UNITED STATES PATENT AND TRADEMARK OFFICE

APPLICATION NO.	FILING DATE	FIRST NAMED INVENTOR	ATTORNEY DOCKET NO.	CONFIRMATION NO.
10/805,634	03/19/2004	Mark Gurvich	94/2	3618

Office Action Summary	Application No. 10/805,634	Applicant(s) GURVICH ET AL.	
	Examiner Kimberly E. Glenn	Art Unit 2817

DETAILED ACTION

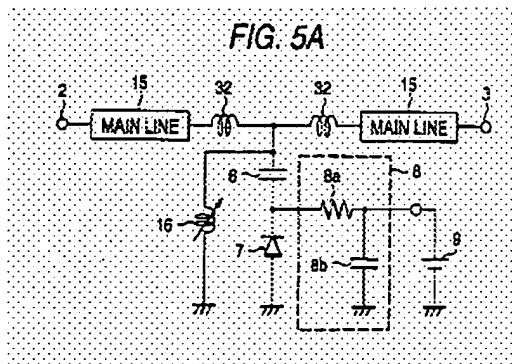
Seino disclose in figure 5a, a circuit comprising of an variable capacity element 7, a direct current power supply is coupled to the variable capacity element to control the capacitance, a variable inductor is coupled in parallel with the variable capacity element. The variable inductor and variable capacity elements are components in a phase compensation circuit connected to a transmission line. The phase compensation circuit compensates for phase relative to the temperature. Therefore, the adjusting of the capacitance and inductance will result in a phase compensation, which will inherently shift (delay) the signal that is applied to the input of the transmission line. The variable capacity element has one end connected to the variable inductor and the other end connected to ground. The method steps to the above disclosed apparatus are inherent.

Thus, Seino is shown to teach all the limitation of the claims with exception of the variable inductor being electronically variable virtual inductor.

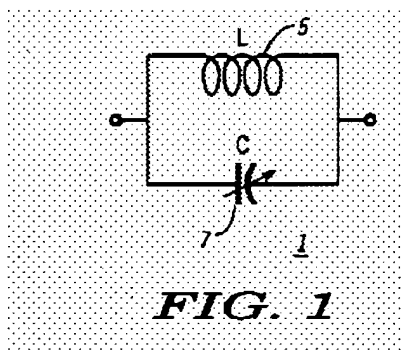
Stengel et al discloses in figure 1, a tunable inductor circuit 1 comprising of an inductor 5 and a variable capacitor 7. A control voltage signal is applied to the variable capacitor, which controls the inductance of tunable inductor circuit 1.

One of ordinary skill in the art would have found to obvious to replace the variable inductor of Seino with tunable inductor circuit as taught by Stengel et al. The motivation for this modification would have been to provide a tunable inductor circuit capable of dynamic phase control and better performance.
